CITY OF FORT COLLINS

COMMUNITY DEVELOPMENT DEPARTMENT, PLANNING DIVISION

Staff has reviewed Quail Hollow Preliminary PUD and the Phase 1 Final PUD and has the following comments to offer. Revisions reflecting these changes should be submitted by Monday, August 11, 1985.

#144-80D QUAIL HOLLOW PUD, PHASE ONE - Final

DETAIL NO. 2

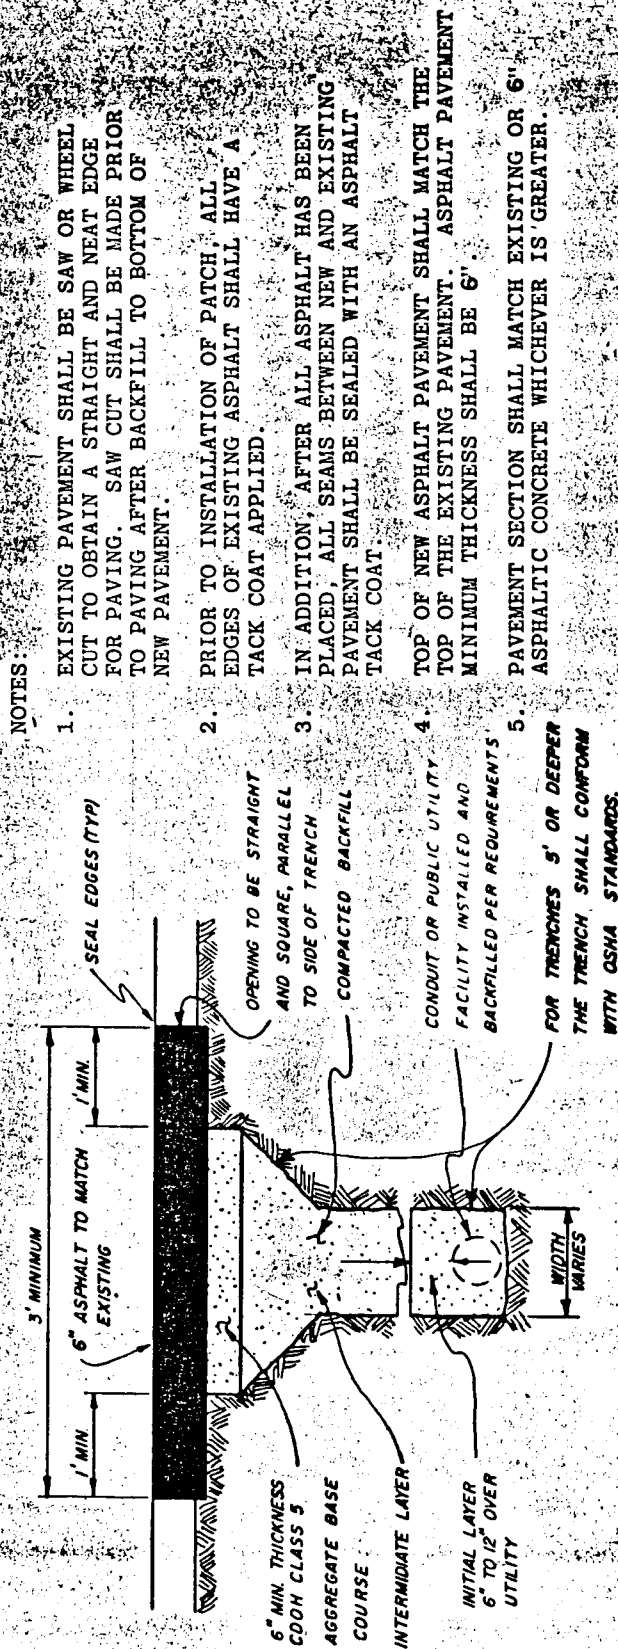
- A. The patch shall be in accordance to City standard as per "Replacing Asphaltic Concrete Pavement On Aggregate Base" from the manual entitled "Design Criteria and Standards for Streets" (Detail No.2) page PD 2. Copy enclosed.

- B. The patch shall be a minimum of 3/4 inches asphalt overlay to lip of gutter to lip of gutter.
 - C. The patch shall overlap the cut by one foot on the other two sides.
